**PETITION FOR WITHDRAWAL OF HOLDING OF ABANDONMENT**

For: MODULAR REACTOR  
CONTAINMENT SYSTEM

**AMENDMENT AFTER FINAL OFFICE ACTION**

FIG. 4

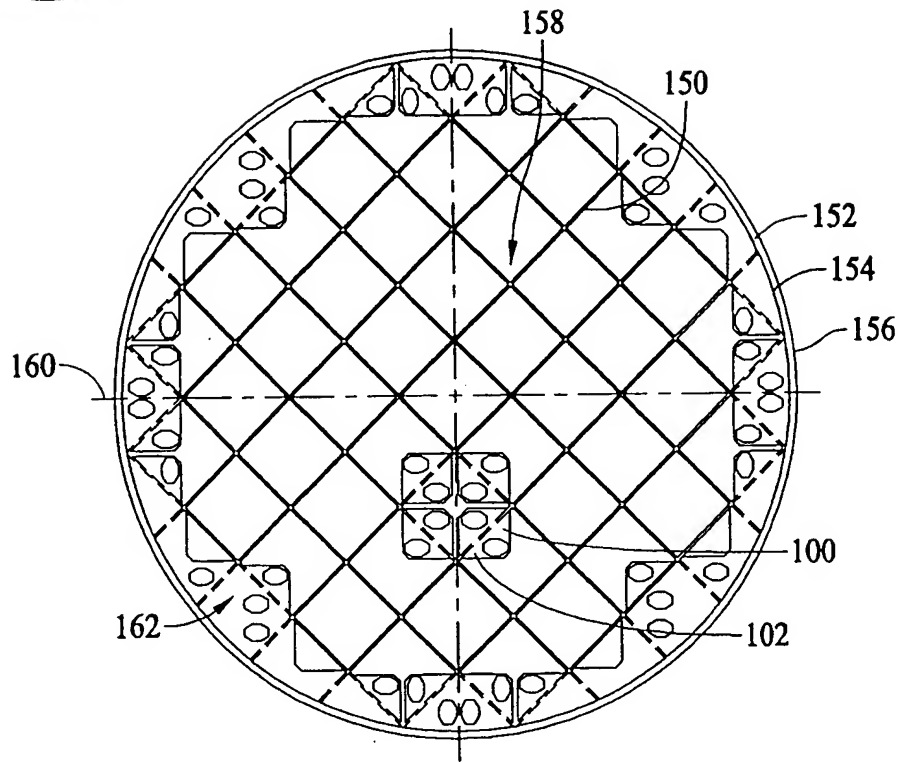
An amended Figure 4 deleting reference number 164 is submitted herewith for approval. Applicants submit that the drawings meet the requirements of 37 CFR 1.48(p)(4). Accordingly, Applicants respectfully request that the objection to the drawings under 37 CFR .48(p)(4) be withdrawn.

Applicants have amended paragraph [0026] and Figure 4 to delete reference number 164. Also, Figure 8 has been amended to remove the protrusion from the beam and reference number 164. Applicants submit that Figure 8 is a sectional view of originally filed Figure 4 that illustrates support beam 150 received in groove 122 of support plate 100. Support for this Figure is found in originally filed paragraph [0026] and originally filed Claim 1. No new matter has been added. Further, Applicants submit that Figure 8 is a schematic illustration that shows the relationship of the elements of the core support apparatus. Figure 8 is not a construction drawing meant to show exact sizes of the beam, the support plate, and the groove.

FIG. 8

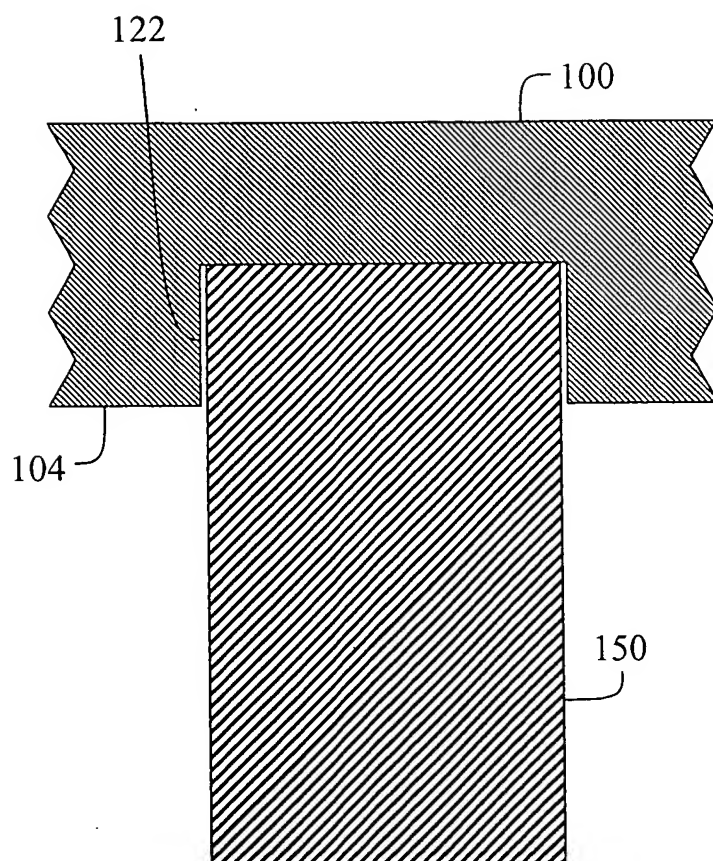
Applicants submit herewith an amended Figure 8, for approval. Figure 8 is a sectional view of originally filed Figure 4 that illustrates support beam 150 received in groove 122 of support plate 100. Support for this amendment is found in paragraph [0026] and originally filed Claim 1. No new matter has been added.

beam is positioned in said groove, said removable support plate in direct contact with said beam". Amended Figure 8 clearly illustrates the support beam 150 positioned in the groove 122 and that the support beam 150 and the support plate 100 are in direct contact.
